Environmental Impact Analysis
Process Document
FONPA and Supporting AF Form 813

Title: Construct FAA Localizer Antenna
Array and Equipment Shelter
Joint Base Anacostia-Bolling, Washington, D.C.

**FINDING OF NO PRACTICABLE ALTERNATIVE (FONPA)
CONSTRUCT FEDERAL AVIATION ADMINISTRATION (FAA) LOCALIZER
ANTENNA ARRAY AND EQUIPMENT SHELTER
JOINT BASE ANACOSTIA-BOLLING, WASHINGTON, DC**

Front view of proposed 15' high Localizer Antenna Array platform at JBAB. Looking from Hains Point Park Promenade, across the Potomac River. (ground elev. 4', eye alt. 10')

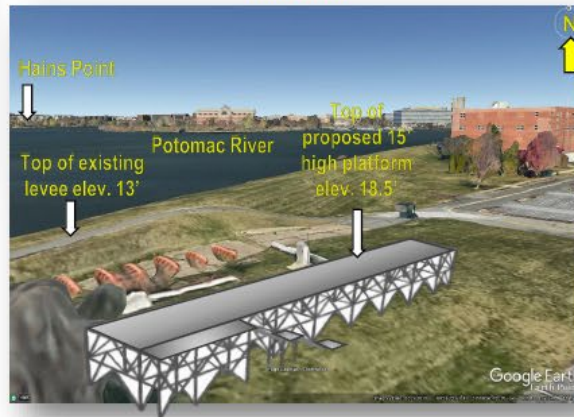
Block 9, Water Resources: The project is within the 100-year floodplain; consequently, compliance with Executive Orders (EO) 11988 and 13690 are required. The construction standards of the equipment shelter account for a 3 ft. flood elevation. The array platform will be raised 15 feet. Both structures will have permeable gravel underneath that allows water to infiltrate.

Figure 4: Buried Concrete Exhibit

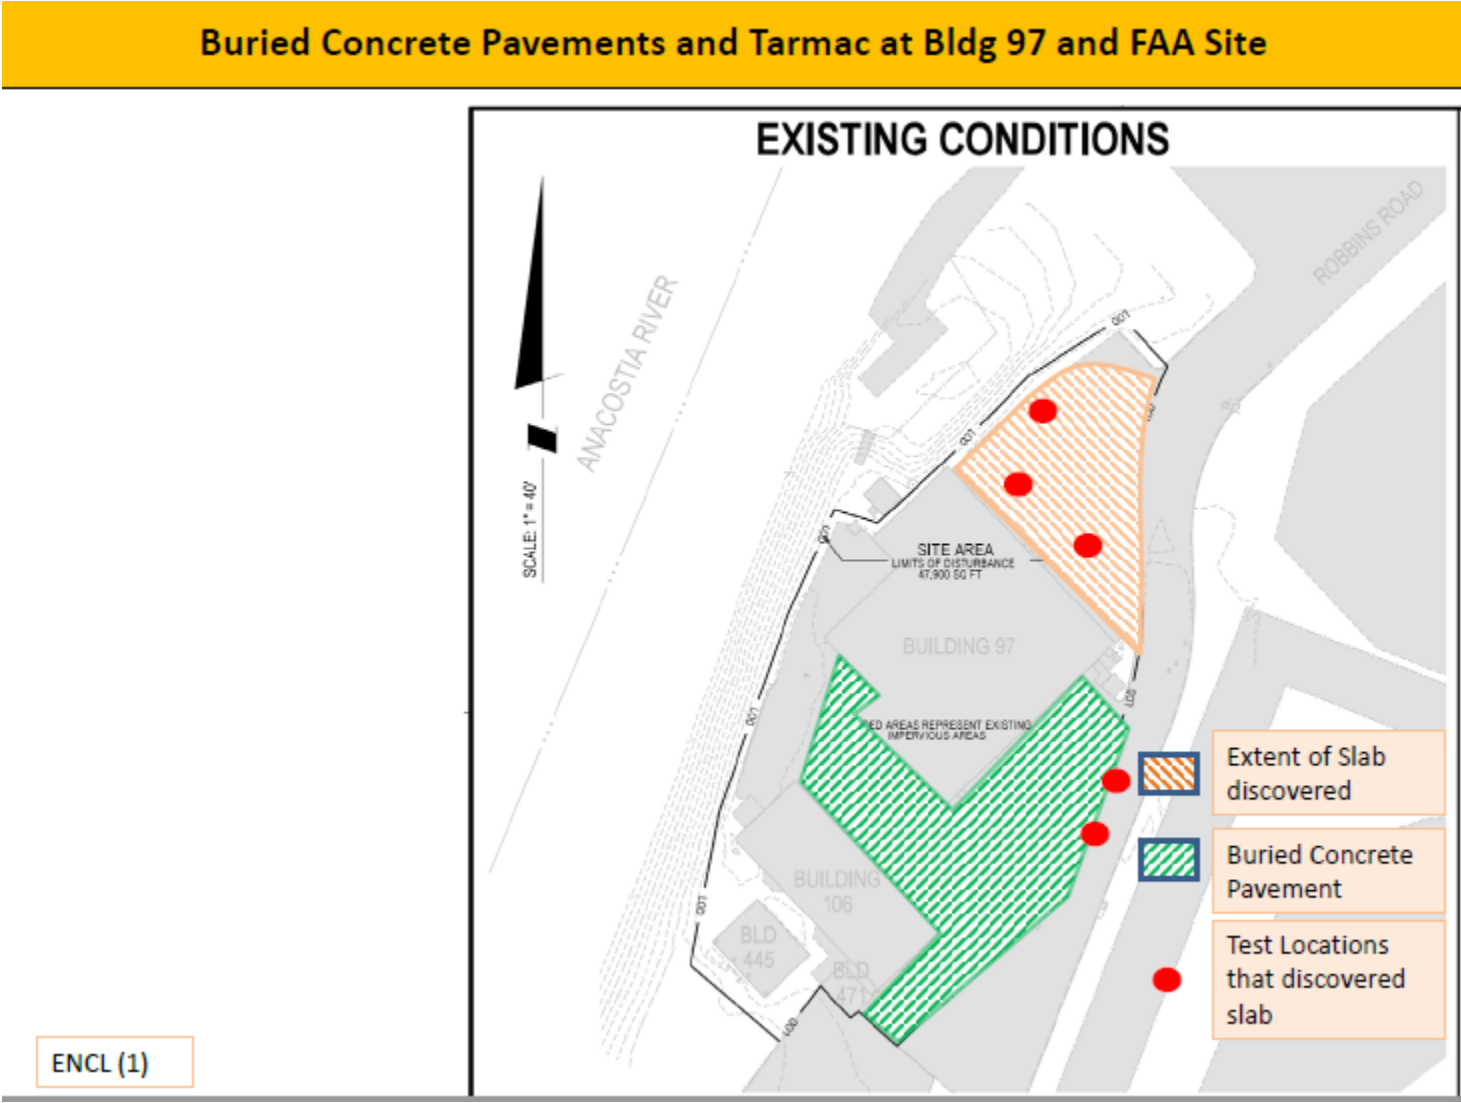
1. The project will not require a new or replacement tank.
2. The project will not require the relocation of a tank.
3. Two underground storage tanks that were previously abandoned in place by filling with concrete are located in the close proximity to the project. Per the provided set of plans and drawings, these tanks should not conflict with the localizer antenna facility. There are no other POL, spills or tanks concerns for this project.
